**8. Page 96-102, SIR Response 35 and Page 123-129, SIR Response 42**

PROJECT			
KIRBY IN SITU OIL SANDS EXPANSION PROJECT			
TITLE			
REVISED STUDY AREA (JUNE 2013)			
	PROJECT	12-1346-0014	FILE No.
	DESIGN	TGC	27 May 2013
	GIS	SS	13 Jun. 2013
	CHECK	TGC	13 Jun. 2013
	REVIEW	MC	13 Jun. 2013
			SCALE AS SHOWN
			REV. 0
<b>FIGURE: 8-1</b>

**Email correspondence between ESRD and Canadian Natural from June 13, 2013  
to July 8, 2013 regarding initial June 14 response to Round 3 SIR 8**

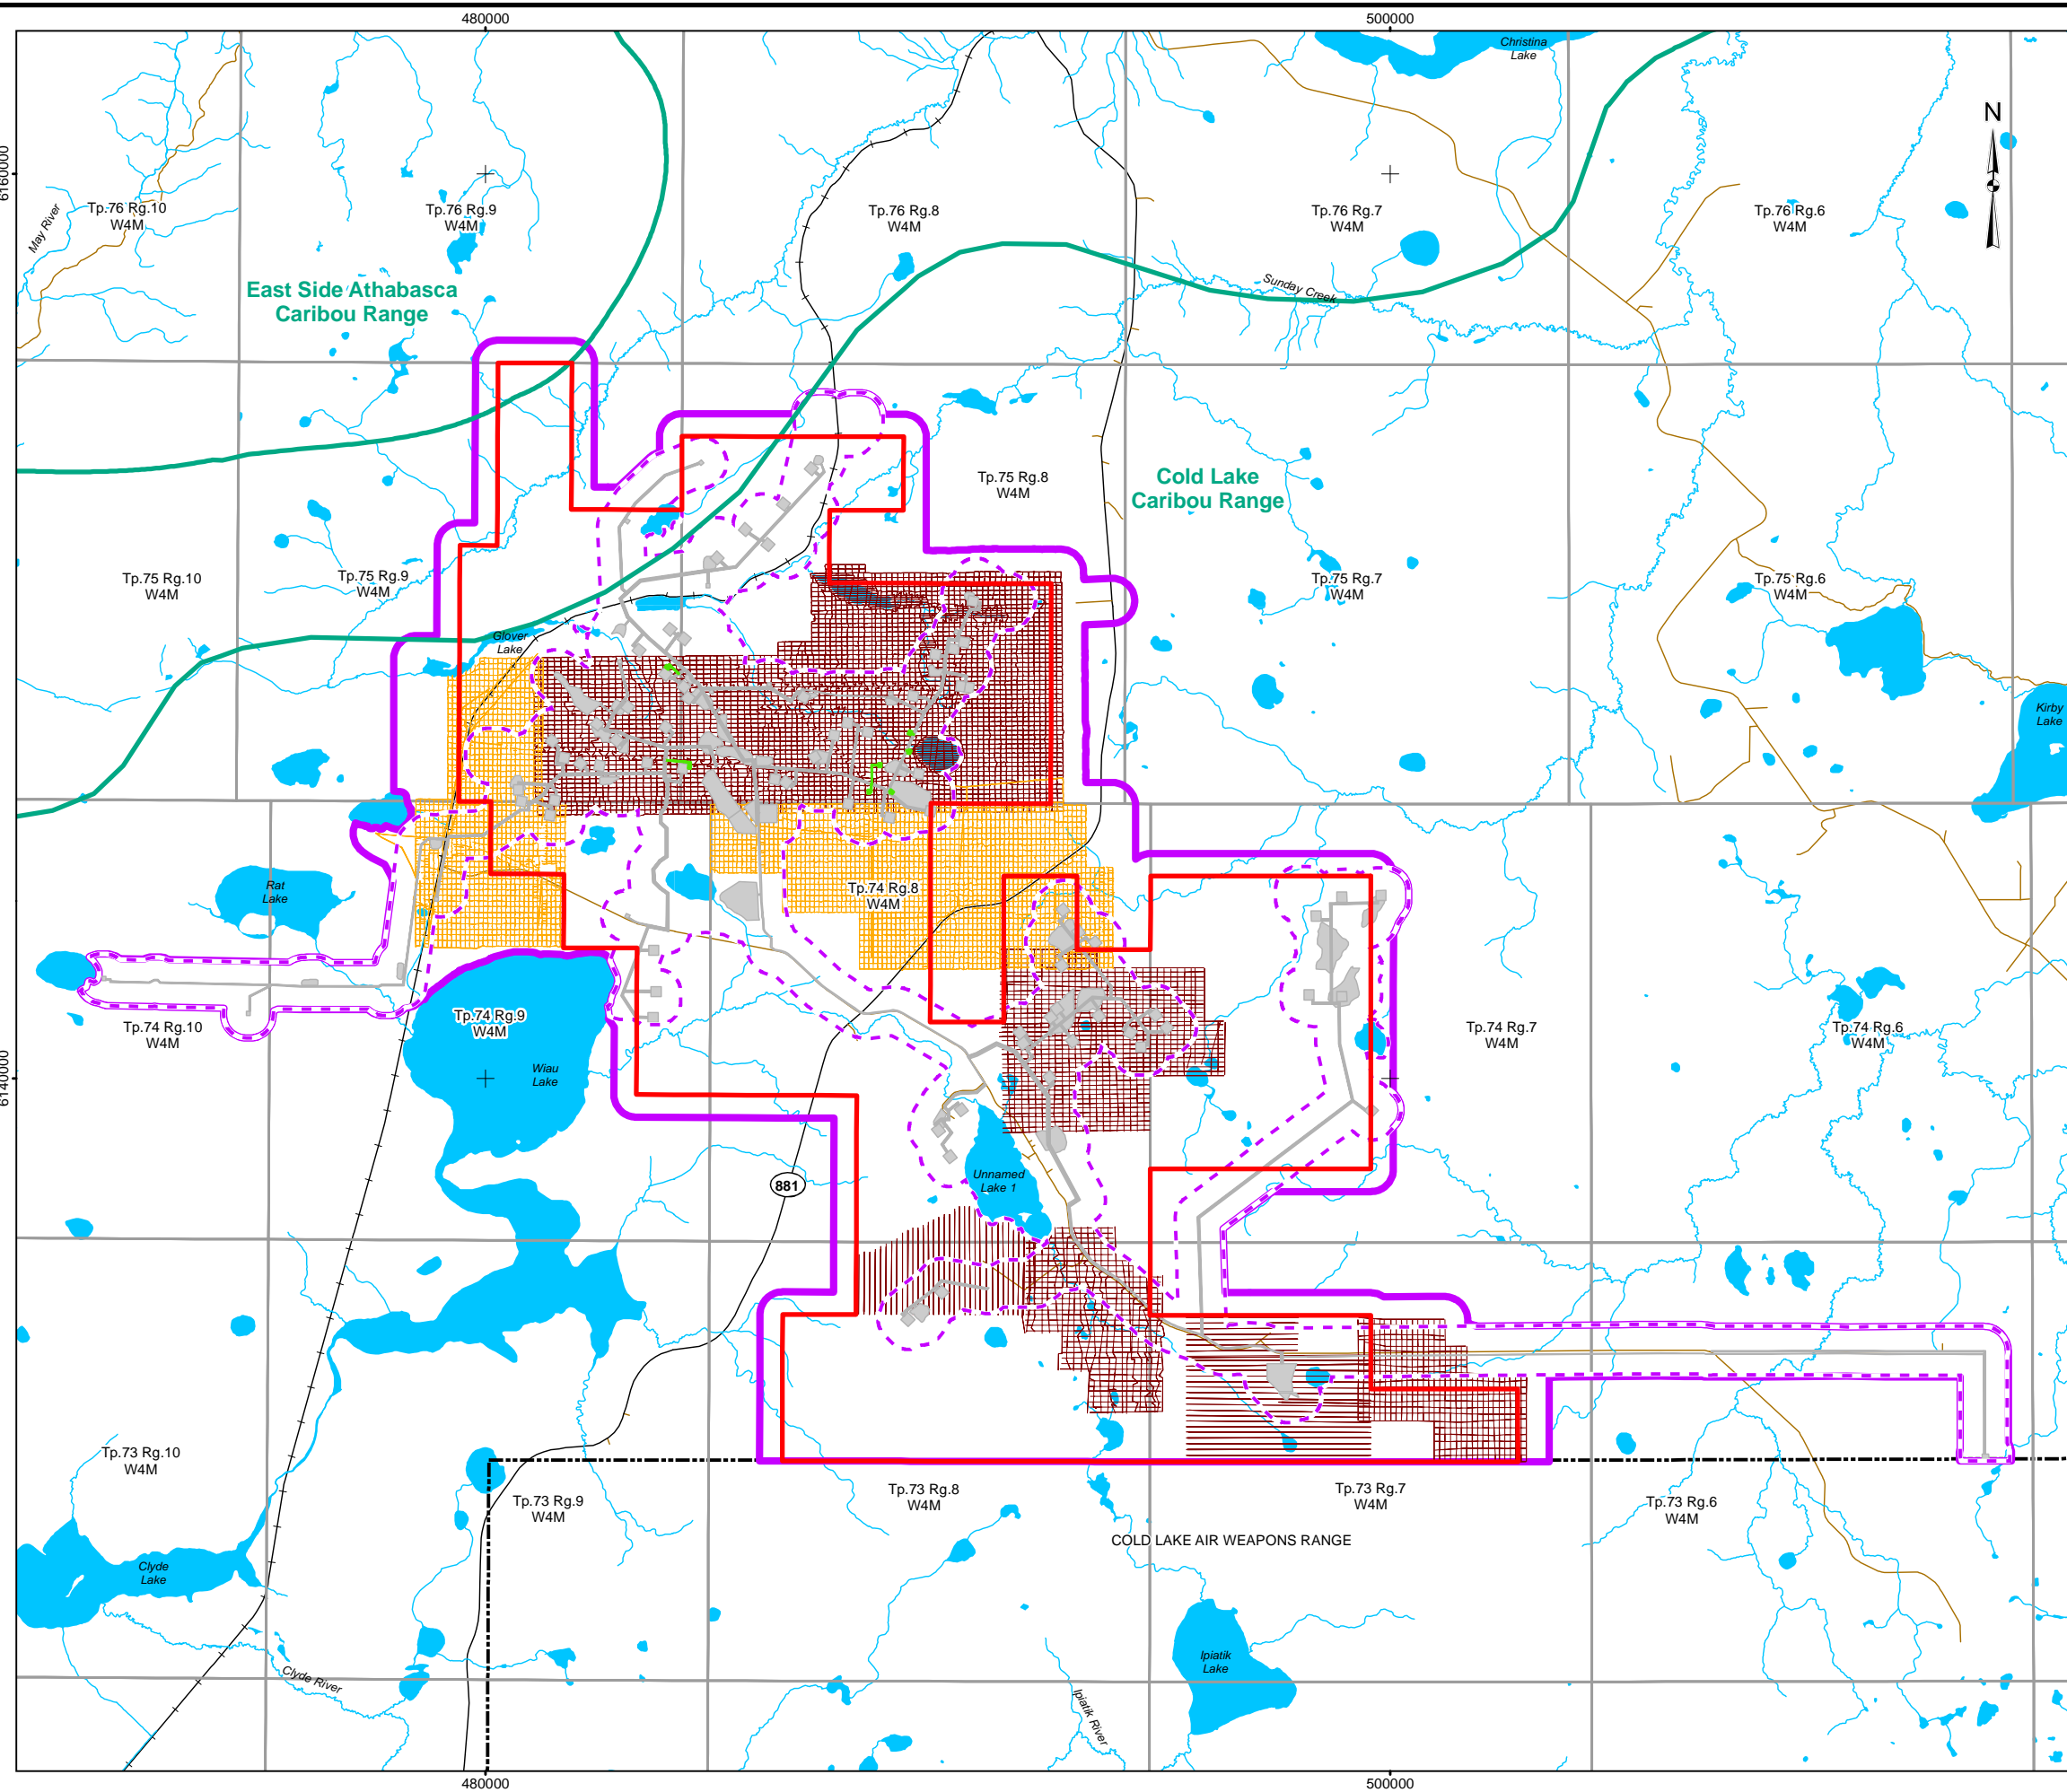
- c. Provide a map depicting the extent of exploration conducted in support of the project, to date, in contrast to the LSA. If the areal extent of exploration undertaken in support of the project is not circumscribed by the boundary of the LSA, adjust the LSA and refine the impact predictions presented. Ensure the LSA is appropriately sized to consider any other areas of impact noted in the response to a. and any future disturbance as described in c.**

- e. A description and map of a modified local study area (LSA) the boundary of which circumscribes all project-related disturbance including past and expected exploration and monitoring (4D seismic and/or monitoring/observation wells) footprint. Identify all disturbance and draw the 500 metre buffer.**

The LSA has been revised using a smoothed buffer of at least 500 m around the lease area or disturbances that are related to the Project ([Figure 8-1](#)). This revised study area encapsulates:

- Project footprint;
- All Project-related seismic (baseline [1997 to 2010], 2012/2013 program and forecasted);
- Seven observation wells (discussed in responses to [Round 1 SIR 19](#), [Round 2 ESRD SIR 19](#) and [Round 3 ESRD SIR 5](#));
- All Project-related oil sands exploration (OSE) wells; and
- Access for Project-related seismic, observation wells and OSE wells.

- b. All areas of impact associated with Project-related disturbances are identified in the response to part a.
- c. See the response to part a, and [Figure 8-1](#).

- e. See the response to part a, and [Figure 8-1](#).
- f. Disturbances in the revised study area in the Baseline Case for the purpose of this reassessment are detailed in [Table 8-4](#).

PROJECT				
KIRBY IN SITU OIL SANDS EXPANSION PROJECT				
TITLE				
<b>REVISED STUDY AREA (JUNE 2013)</b>				
	PROJECT	12-1346-0014	FILE No.	
	DESIGN	TGC	27 May 2013	SCALE AS SHOWN
	GIS	SS	13 Jun. 2013	REV. 0
	CHECK	TGC	13 Jun. 2013	<b>FIGURE: 8-1</b>
REVIEW	MC	13 Jun. 2013

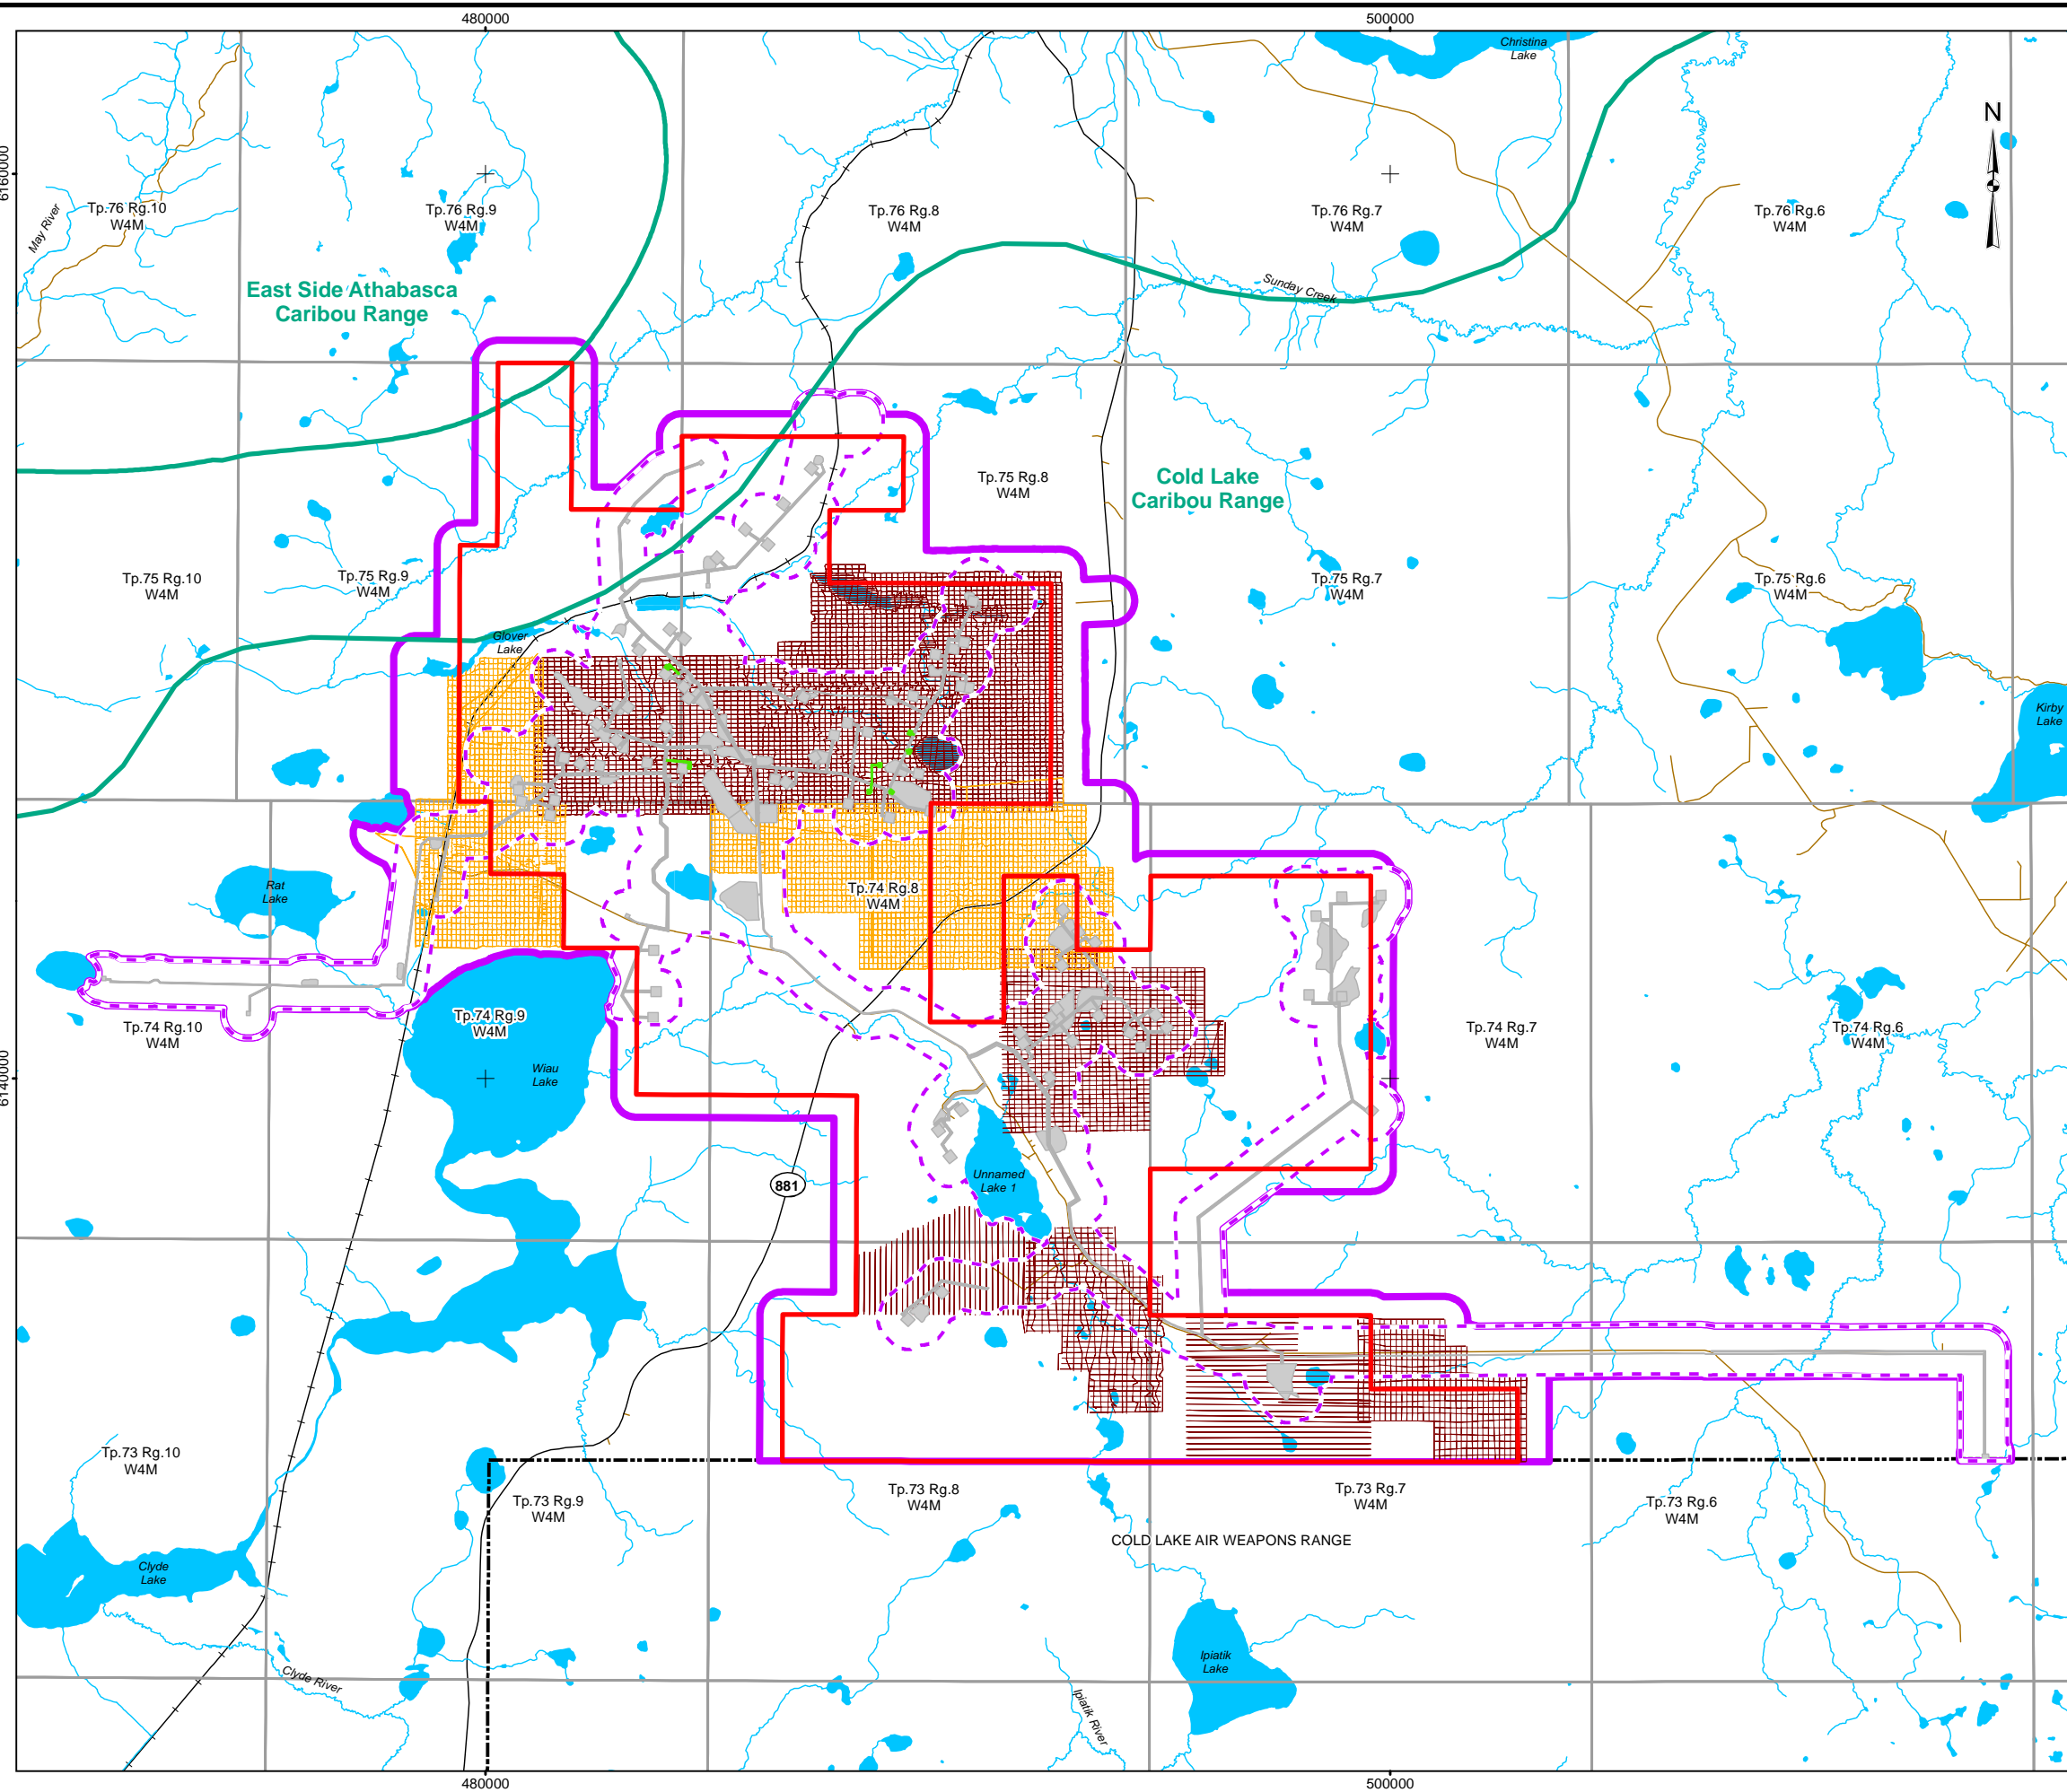
- c. **Provide a map depicting the extent of exploration conducted in support of the project, to date, in contrast to the LSA. If the areal extent of exploration undertaken in support of the project is not circumscribed by the boundary of the LSA, adjust the LSA and refine the impact predictions presented. Ensure the LSA is appropriately sized to consider any other areas of impact noted in the response to a. and any future disturbance as described in c.**

- e. **A description and map of a modified local study area (LSA) the boundary of which circumscribes all project-related disturbance including past and expected exploration and monitoring (4D seismic and/or monitoring/observation wells) footprint. Identify all disturbance and draw the 500 metre buffer.**

The LSA has been revised using a smoothed buffer of at least 500 m around the lease area or disturbances that are related to the Project ([Figure 8-1](#)). This revised study area encapsulates:

- Project footprint;
- All Project-related seismic (baseline [1997 to 2010], 2012/2013 program and forecasted);
- Seven observation wells (discussed in responses to [Round 1 SIR 19](#), [Round 2 ESRD SIR 19](#) and [Round 3 ESRD SIR 5](#));
- All Project-related oil sands exploration (OSE) wells; and
- Access for Project-related seismic, observation wells and OSE wells.

- e. See the response to part a, and [Figure 8-1](#).
- f. Disturbances in the revised study area in the Baseline Case for the purpose of this reassessment are detailed in [Table 8-4](#).

(Figure 8-1). In other words, a 500 m buffer around disturbances related to the Project affects habitat within the Cold Lake caribou range, but does not affect caribou habitat within the ESAR range. The range of the Cold Lake caribou herd (672,422 ha), which is currently in decline and considered to be not self-sustaining, is estimated by Environment Canada to be 15% undisturbed (Environment Canada 2012). Therefore, all undisturbed habitat within the Cold Lake caribou herd range is critical habitat, as defined by Environment Canada (2012).
